City of Portland, Maine - Building or Use Permit Application
 389 Congress Street, 04101 Tel: (207) 874-8703, Fax: (207) 874-8716

Permit No: 04-0024	Issue Date: ISSUED MAR 05 2004	CBL: 392 A015001
-----------------------	-----------------------------------	---------------------

Proposed Project Description:
3300 sf Single Family home w/rear deck, front porch, 2 car attached garage

Dept: Zoning **Status:** Approved with Conditions **Reviewer:** Marge Schmuckal **Approval Date:** 01/15/2004
Note: 02/12/04 received a revised site plan **Ok to Issue:**
 3/4/04 Had to resign another new sheet for the permit

Front Porch Detail

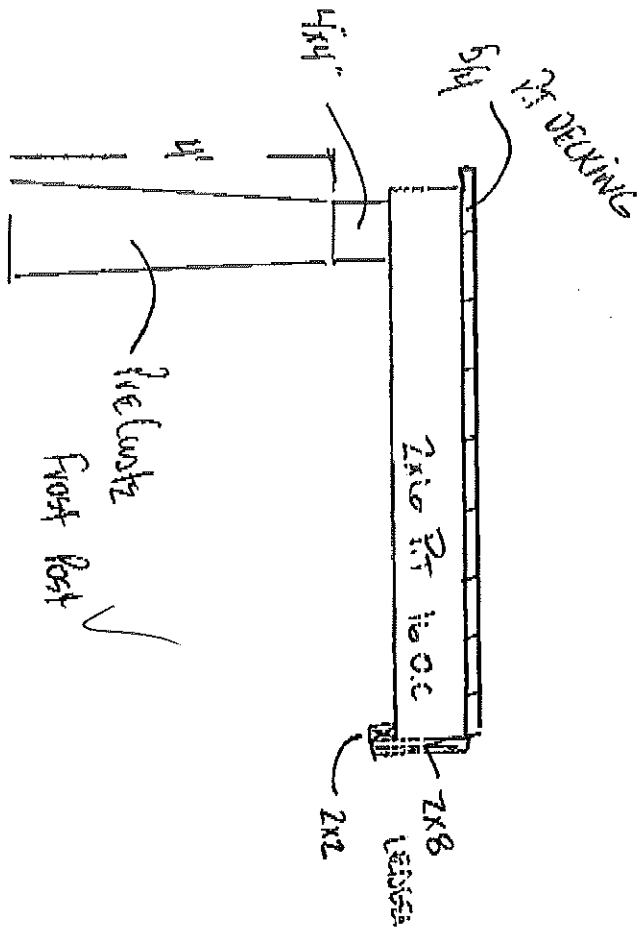
RE: PORCH & DECK DETAIL
